Comment (Comment r02-119, r02-70 clause 145.4.1 page 217 line 39)

Annex A – PSE – PD configurations for specifying isolation.

Figure 1: Dual-signature, single load PD.

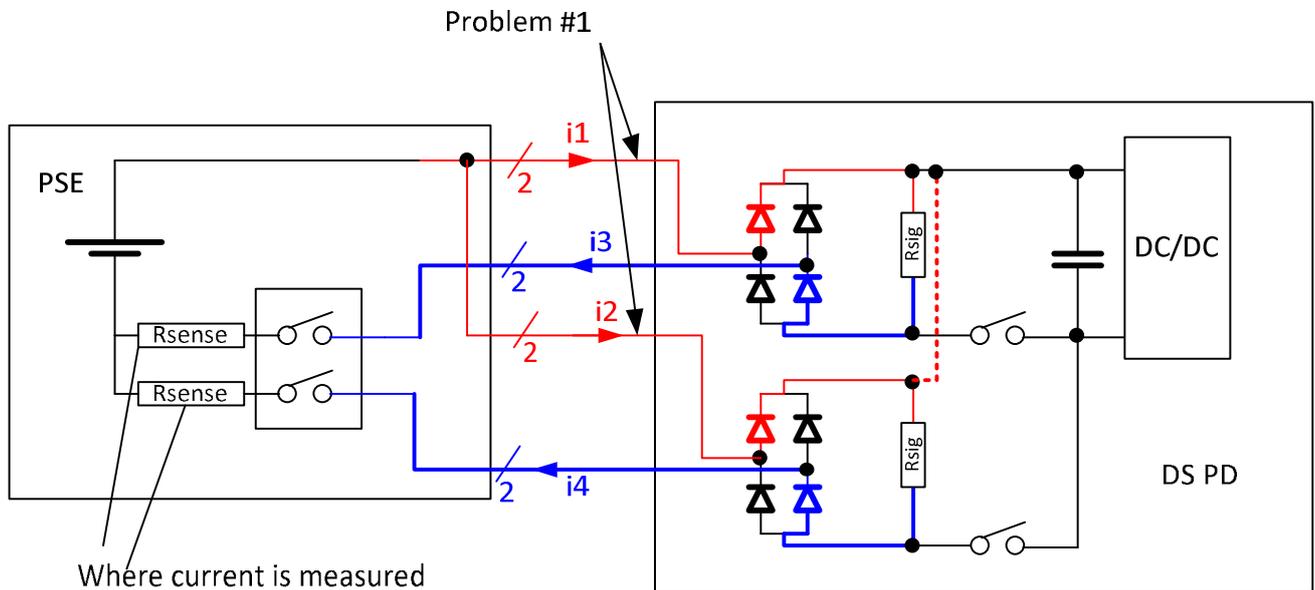
- Switching on the negative is mandatory
- Measuring current on the negative when switching on the negative is the only possible choice for 4-pair operation since measuring on the positive will result with pairs currents that are not correlated to the negative pairs currents due to unbalance. As a result, it is guaranteed only in the negative pairs, that PSE will support PD successfully when measuring the pair current for connection check, detection and classification circuits in dual-signature PDs.
- In addition, the positive side is tied together at the PSE side which effectively, tied the positive pairs at the PD side as well.

Figure 2: Dual-signature, dual load PD.

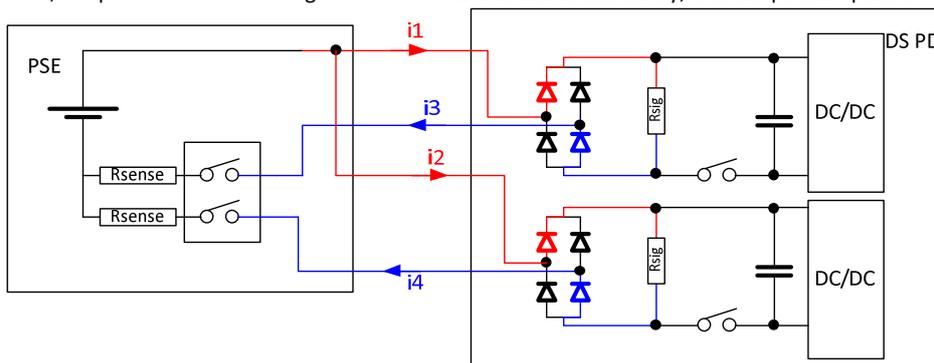
By definition, the positive pairs and negative pairs are isolated in the PD primary side (secondary may have common GND and typically this is the case). However, since as in the previous case the PSE is required to support switching on the negative pairs, PD is not guaranteed to be supported on the positive pairs making the isolation requirements on the PD positive pairs with no value.
